Access Compliance Report

Public Rights-of-Way

(Curb Ramps)

Intersection ID: 45067	Main Street: DARBYWINE_DR	Cross Street: FIFENDRUM_LN	Location: SE
ADA ID: 7658192E15BF	Ramp Type: PerpDiag	Initial Pass/Fail: Fail	Overall Compliance: No
Severity Score: 37.5			
Codes/Mitigation Info/Possible Solution		Field Measurements/Component Compliance

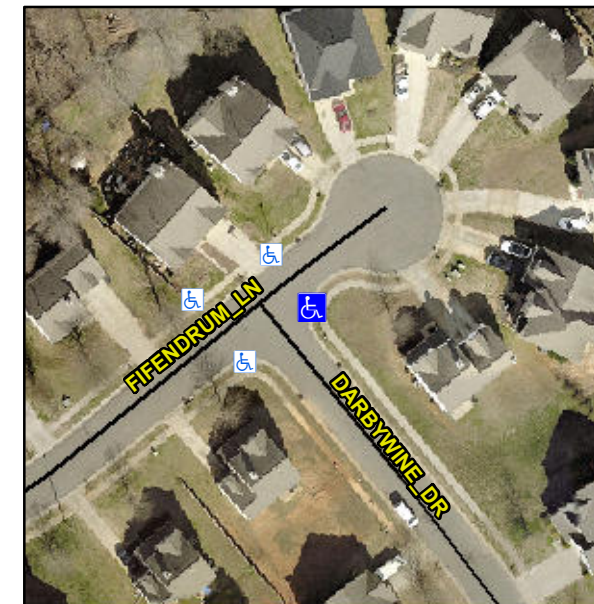
Not Found, R304.2.2, R304.5.3

Compliance	Description	Data	Compliance	Description	Data
N/A	Ramp Length (in)	46.0	No	Ramp Slope (%)	9.8
Yes	Ramp Width (in)	64.0	No	Ramp XSlope (%)	11.4
N/A	Flare Type LT	N/A	N/A	Flare Type RT	N/A
N/A	Flare Slope LT (%)	N/A	N/A	Flare Slope RT (%)	N/A
N/A	Flare Traversable LT?	N/A	N/A	Flare Traversable RT?	N/A
N/A	Landing Length (in)	N/A	N/A	DWS Provided?	N/A
N/A	Landing Width (in)	N/A	N/A	DWS Contrast?	N/A
N/A	Landing Slope (%)	N/A	N/A	DWS Length (in)	N/A
N/A	Landing X Slope (%)	N/A	N/A	DWS Full Width?	N/A
N/A	Landing Curb? (Y/N)	N/A	N/A	DWS Offset (in)	N/A
N/A	Shared Landing?	N/A			
N/A	Gutter Ponding?	N/A	N/A	Gutter Slope (%)	N/A
N/A	Gutter Lip Ht (in)	N/A	N/A	Gutter X Slope (%)	N/A
N/A	Painted X Walk1?	No	N/A	Painted X Walk2?	No
	X Walk 1 Direction	To N		X Walk 2 Direction	To SW
N/A	X Walk 1 Width (in)	N/A	N/A	X Walk 2 Width (in)	N/A
	X Walk 1 Slope (%)	0.3		X Walk 2 Slope (%)	7.6
	X Walk 1 X Slope (%)	9.0		X Walk 2 X Slope (%)	0.3

N/A	Ramp inside XWalk1?	N/A	N/A	Ramp inside XWalk2?	N/A
	Road Slope (%)	8.7	N/A	Clear Space?	N/A
	Road X Slope (%)	6.1	N/A	Clear Space to XWalk (in)	N/A
N/A	Any Obstructions?	N/A	N/A	Storm Grate/Utility Hazard?	N/A
	Obstruction Type			Storm Grate/Utility Type	
		N/A			N/A
		Yes		Surface Condition? (G/P)	Good

Remove & Replace Curb Ramp With Two New Directional Ramps or Equivalent.
